DEPARTMENT OF THE ARMY  
RAVENNA ARMY AMMUNITION PLANT  
8451 STATE ROUTE 5  
RAVENNA, OHIO 44266-9297

RE: Request of Open Burning Follow-on Submittal

RE: RAVENNA ARMY AMMUNITION PLANT  
PORTAGE/TRUMBULL COUNTIES  
THERMAL DECOMPOSITION WORKPLAN

**MKM's Response To The Ohio EPA, 03 DEC 02 Comments  
LI 6, 9 & Wet Storage Area (WSA) Thermal Decontamination Work Plans  
Ravenna Army Ammunition Plant**

**MKM Engineers, Inc.**  
 4100 Wilshire Lane  
 Method, TX 75401  
**RAVENNA ARMY AMMUNITION  
 PLANT**  
 Ravenna, Ohio  
**Load Line 9 Site Map**  
 Scale: 1" = 100'

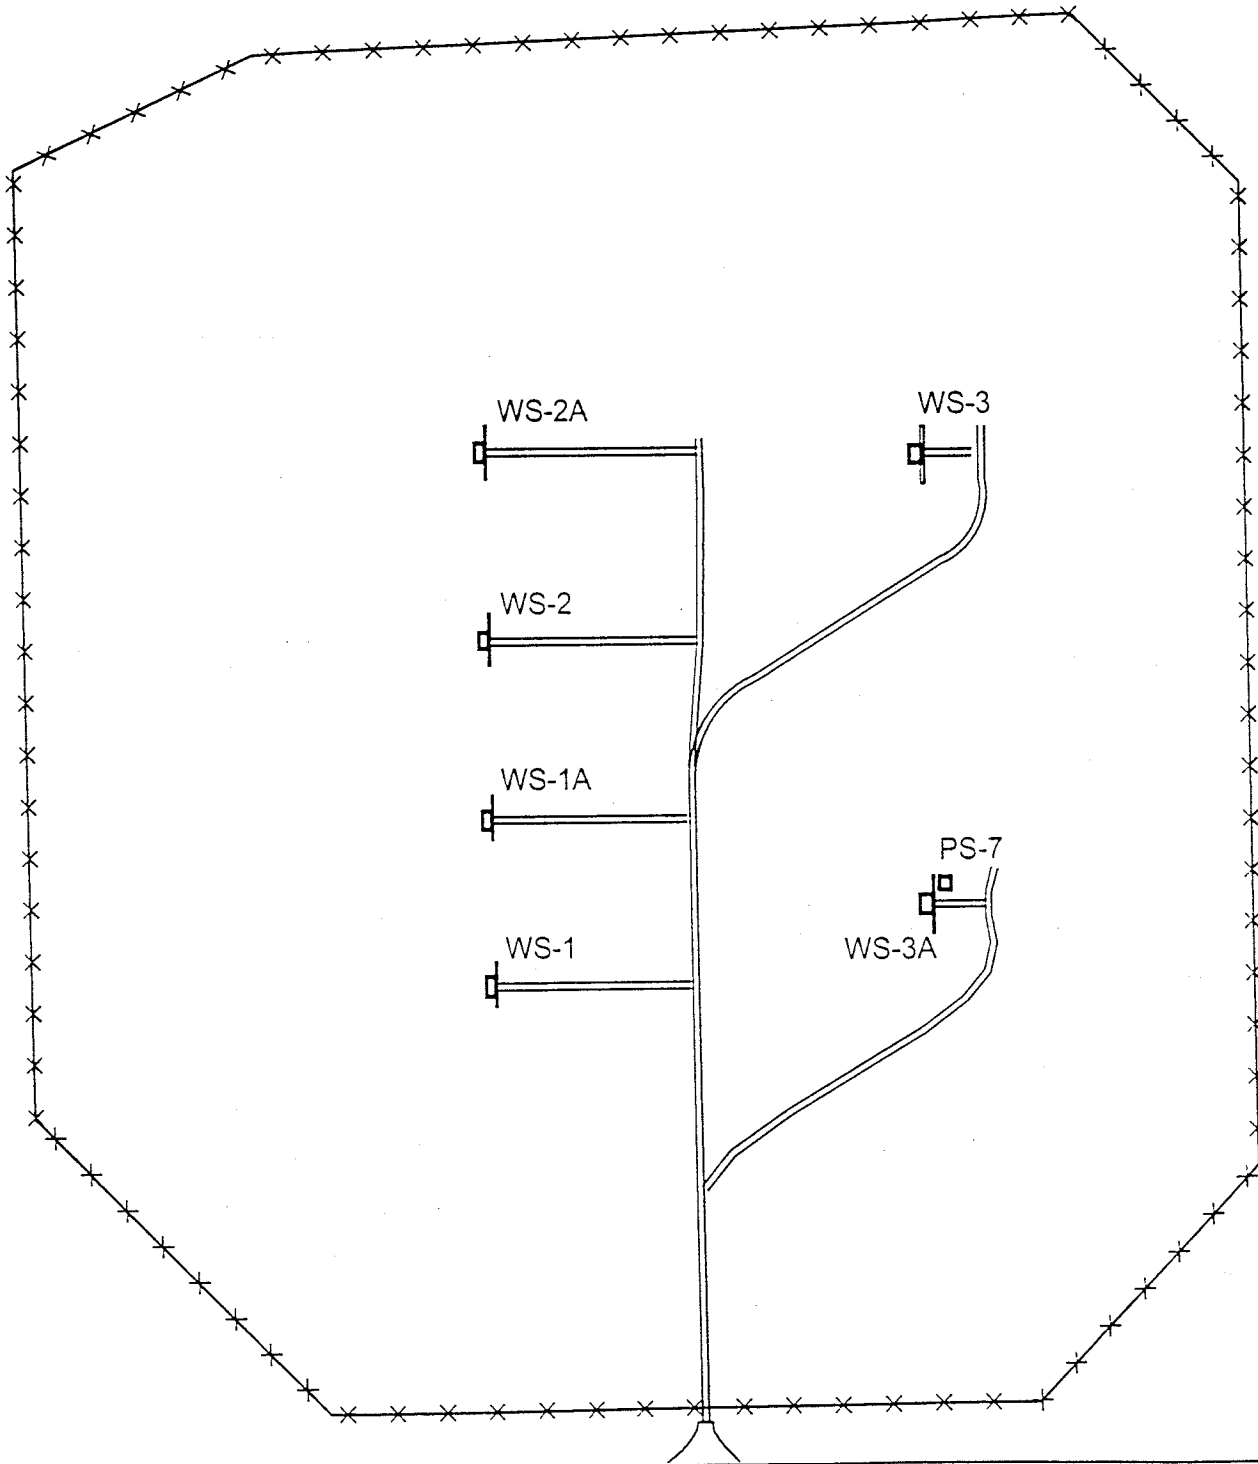
Item 35	Provide a project schedule as referenced on page 43.	A schedule will be provided.
Item 36	In Appendix A, please re-label figure 4 to read, "Load Line 9 Site Map".	Acknowledged.
